APPENDIX C-8: GEOTECHNICAL B-LINE

Memorandum

To	Peter Olak, P.Eng.	Page 1
CC	Dean Simpson, P.E., Zaineb Al Mumayez, P.Eng.	
Subject	Geotechnical Review- Hamilton Rapid Transit Preliminary Design and Feasibility Study (B-line), September 2011	
From	Gwangha Roh, P.Eng., Ph.D., Eric Tiedje, EIT, Ph.D., Miln Harvey, P.Eng., Ph.D.	
Date	October 14, 2016	Project Number 60507521

Figure 4.2.1. Typical Stop Platform Detail
 (SDG B-Line EA Report, Appendix B.7, Figure 5.2).

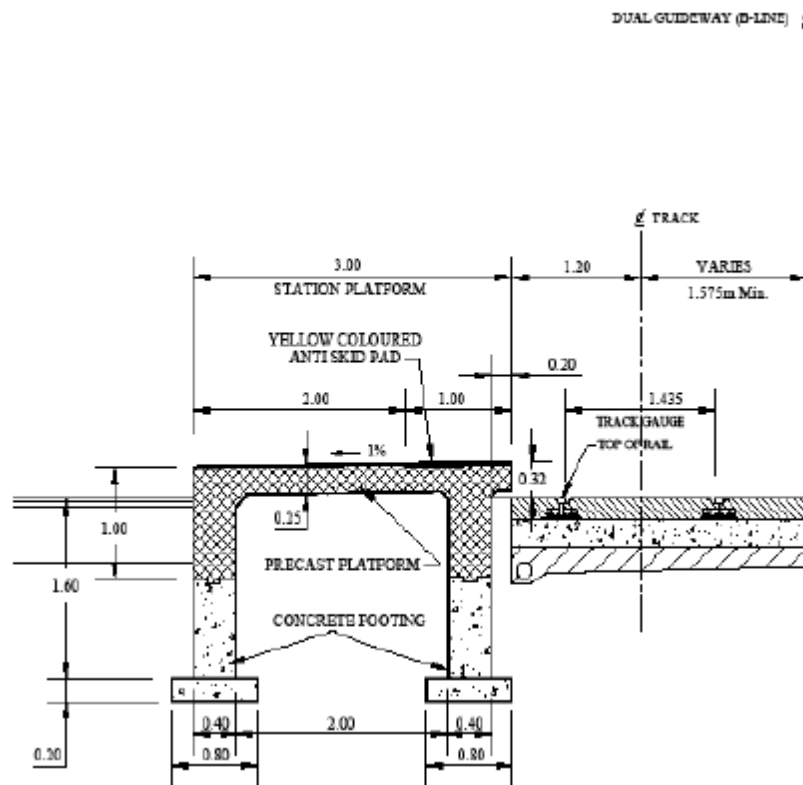
Although the geotechnical EA report noted that foundations should be placed below the frost depth (1.2 m), the typical stop platform detail presented in the geotechnical EA report has about 1.8 m of earth cover, reprinted in Figure 4.2.1. This may be due to site-specific subsurface and groundwater conditions. It is suggested to present a minimum frost cover requirement (1.2 m) on the typical drawing instead of site-specific foundation depth.

In case of using short caisson foundations in a frost susceptible soil with a high groundwater table, adfreezing/frost heave uplift mitigation should also be considered.
